**Preliminary Change Request for the SNS  
1.3 GeV-Compatible Ring**

BNL/SNS TECHNICAL NOTE

NO. 076

May 4, 2000

Figure 5: Layout of the proposed 1.3 GeV-compatible lattice for the Spallation Neutron Source ring.

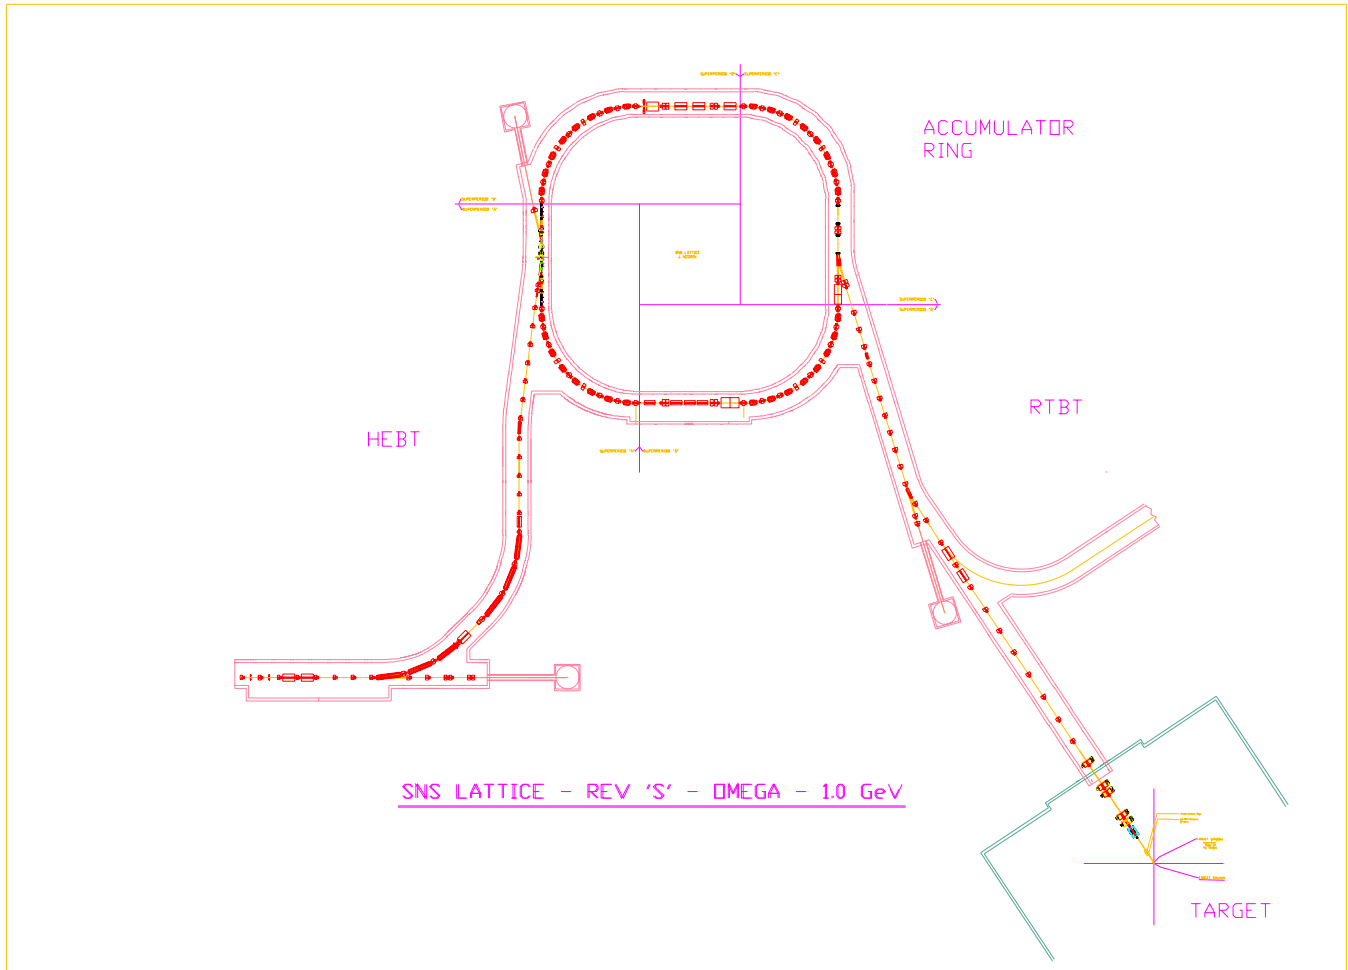
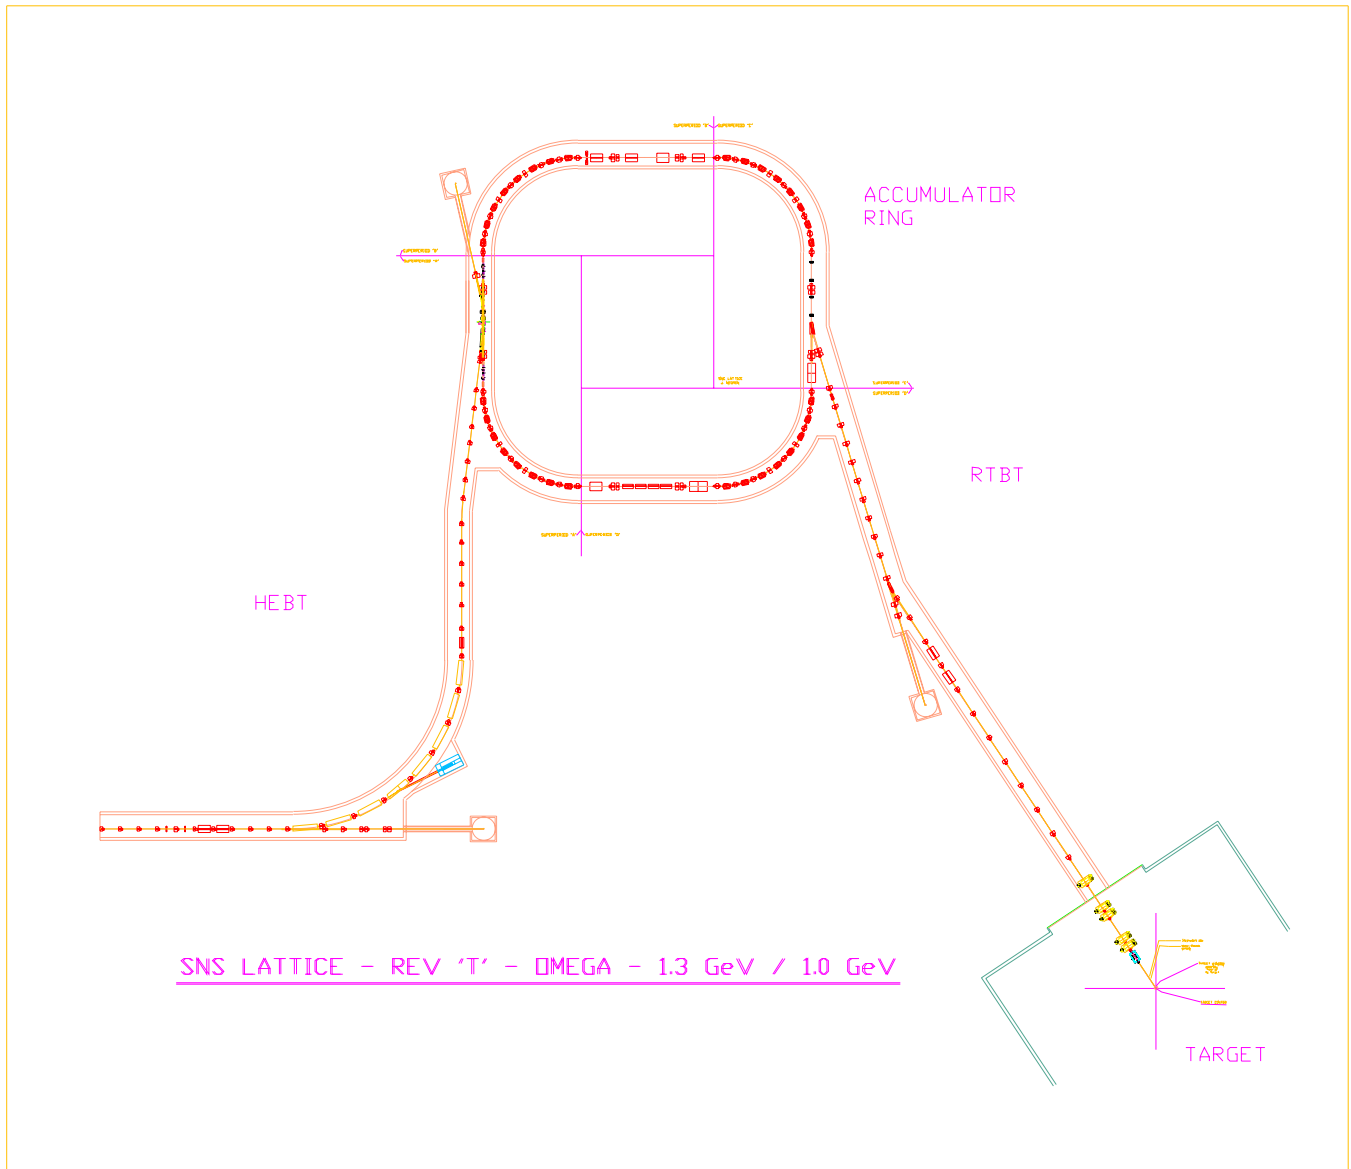
The proposed layout is again in omega configuration, as shown in Figure 5. The bending radius of the  $90^\circ$  achromat bend of the HEBT is increased due to the reduced dipole field. The HEBT length becomes 162 meters, 25 meters longer than the original. The length of the RTBT is assumed unchanged at 150 meters.

The ring lattice is four-fold symmetric with each super-period containing one FODO arc section and one doublet straight section. The arc section consists of four 8-meter long FODO cells, each with a horizontal betatron phase advance of 90 degrees. The dispersion-free straight section consists of one 12.5-meter and two 6.85-meter uninterrupted drift spaces. The increase in ring straight length results in an increase in ring circumference from 220.88 to 248.0 meters.

The general configuration of HEBT, ring, and RTBT remain the same. The length of HEBT line is increased by 25 m. The length of RTBT line is assumed to be the same, provided that the target can be relocated about 10 m from the original site towards the ring.

Figure 6: Schematic layout of the proposed 1.3 GeV-compatible SNS ring.

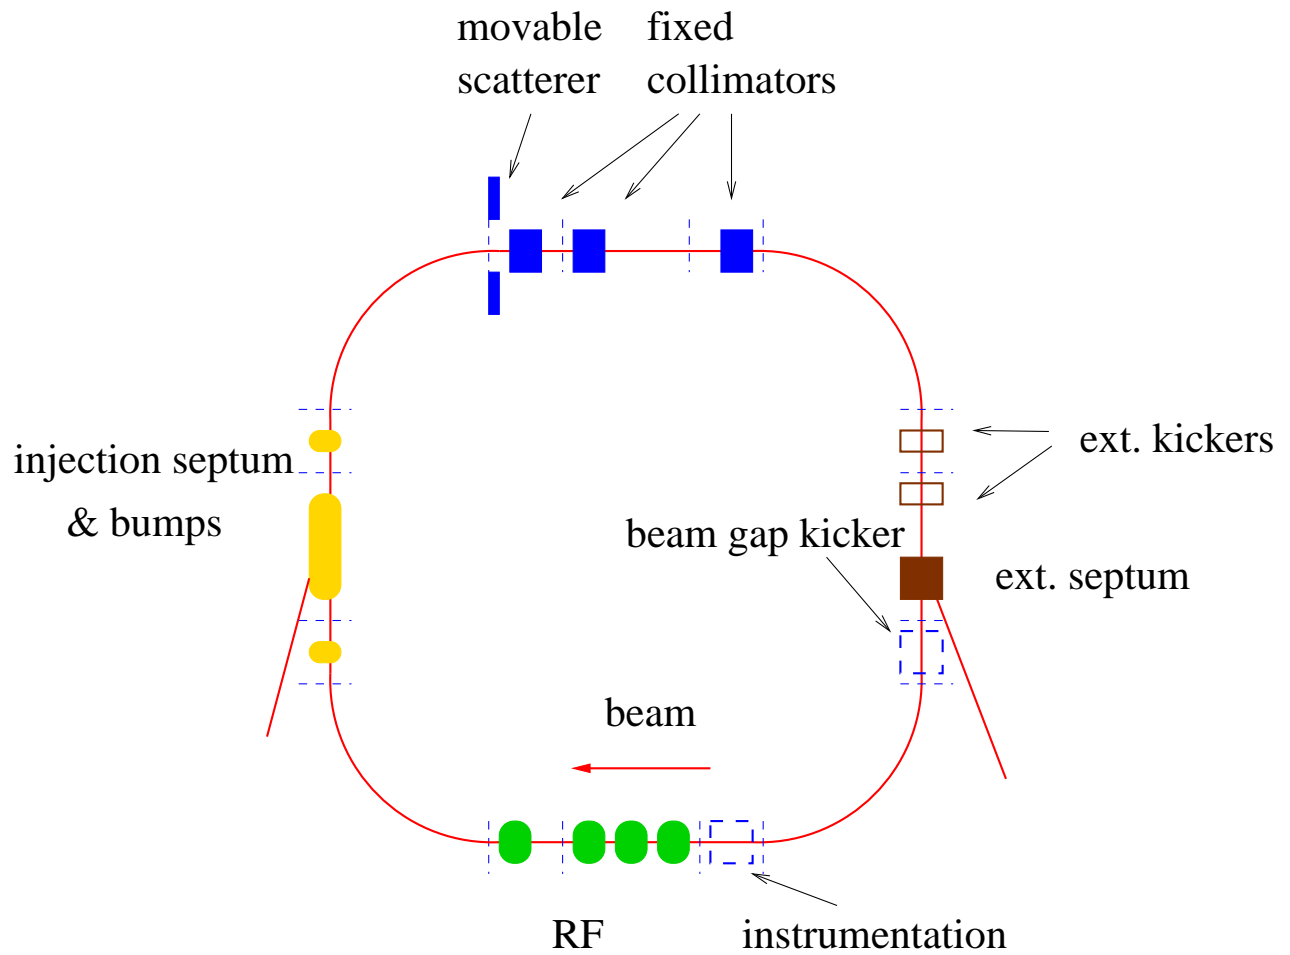
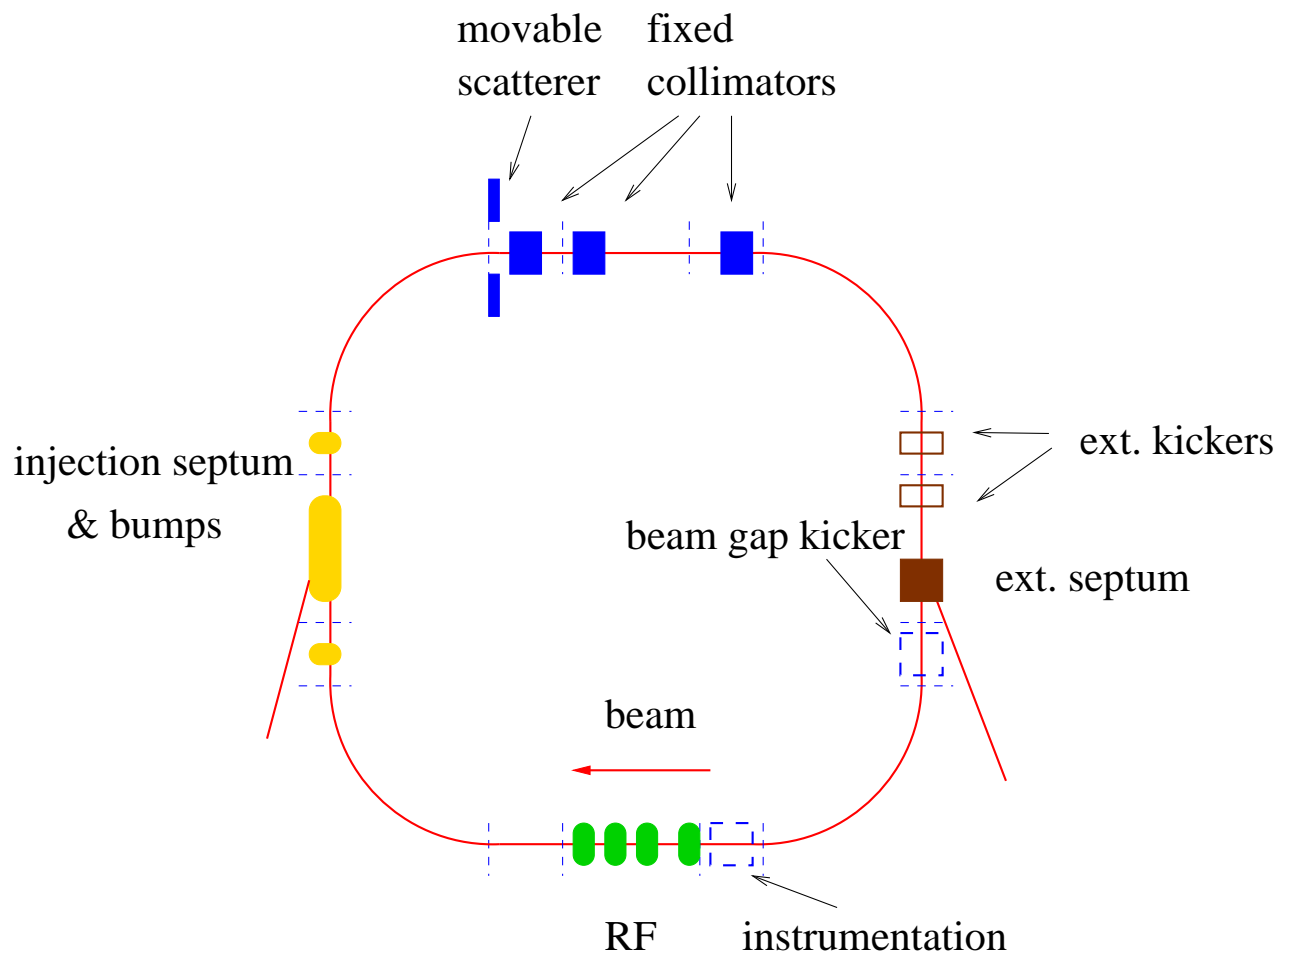
Figure 6 shows the schematic layout of the ring. The four straight sections are mainly designed for beam injection, beam collimation, extraction, and RF systems. All four RF cavities (three  $h = 1$ , one  $h = 2$ ) are located in the same drift space. Figure 7 shows the layout of the lattice magnets (dipole, quadrupole, sextupole, and correctors) in one of the four lattice super-periods. Dipole correctors in both the arc and straight sections are used for misalignment closed orbit correction. The sextupoles in the arc sections are used for chromaticity adjustment, off-momentum optics matching, and momentum aperture improvement. The multi-layer correctors in the straight sections are used for resonance corrections.

Each of the 4 lattice period contains a straight section that has one 12.50 m and two 6.85 m drift spaces. The total straight section length is about 104.8 meters. For each drift space, the “overhead” taken by correctors, BPMs, vacuum pumps, bellows, flanges, etc. is about 1.6 meters. The total usable length is about 85 meters. Each period has 5.2 m – 11 m – 5.2 m structure. The total unclaimed drift space is adequate for an upgrade to a 1.3 GeV machine.

Figure 17: Horizontal schematic layout of the beam injection region of the proposed ring operating at 1.3 GeV.

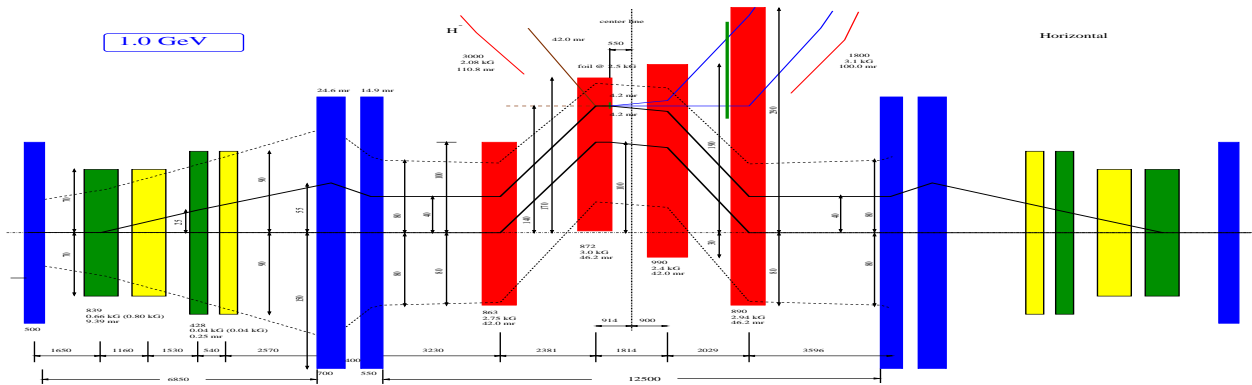
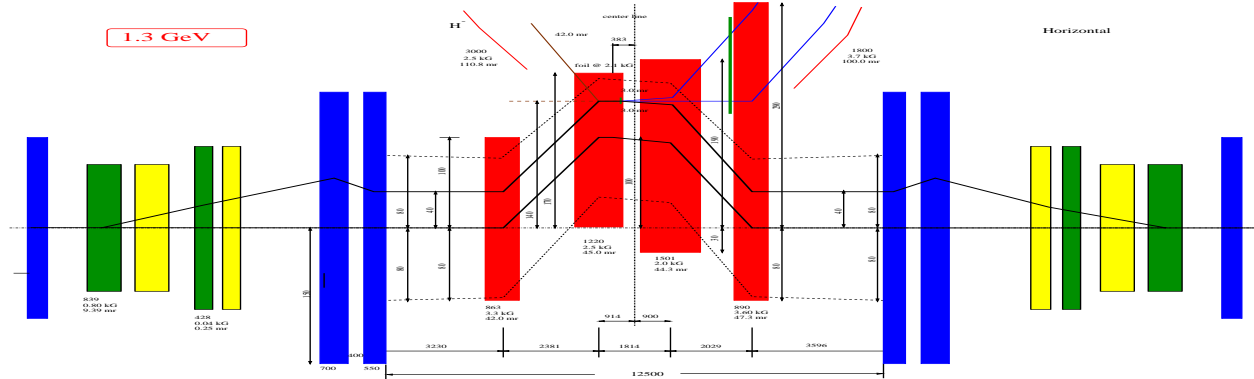
Comparing with 1 GeV operation, for 1.3 GeV operation two injection dipoles need to be

replaced by approximately 40% longer units operating at reduced (20%) fields, as shown in Figure 17. The location of the foil mechanism is also changed. Major parameters for the injection magnets are listed in Table 22. The 2.5 kG field of the magnets INJSEPTM1 and

Extra space is reserved for the replacement of the two dipoles located near the center of the injection. When the machine is upgraded for 1.3 GeV operation, these two dipoles will be replaced by longer magnets operating at lower fields.

Figure 16: Extraction layout and closed orbit of the 1.3 GeV-compatible ring. The two kickers marked with blue color are reserved for 1.3 GeV operation.

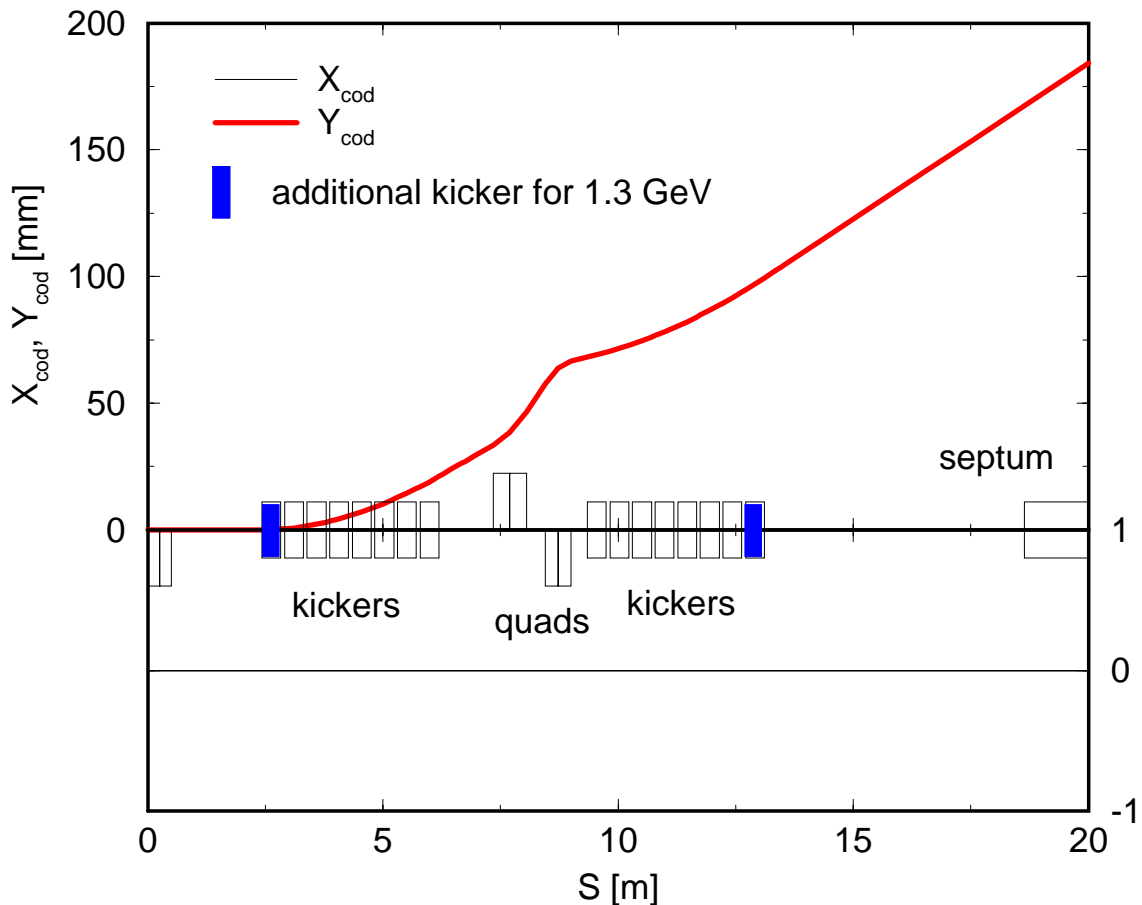
Space is reserved for the addition of two extra kickers for 1.3 GeV operation without changing the location of the existing 14 kickers.

The number and strength of extraction kicker modules remains the same, but the dimension is increased. The length of extraction Lambertson septum is increased from 2.1 to 2.4 m. Space is reserved for addition of two kicker modules for 1.3 GeV operation.
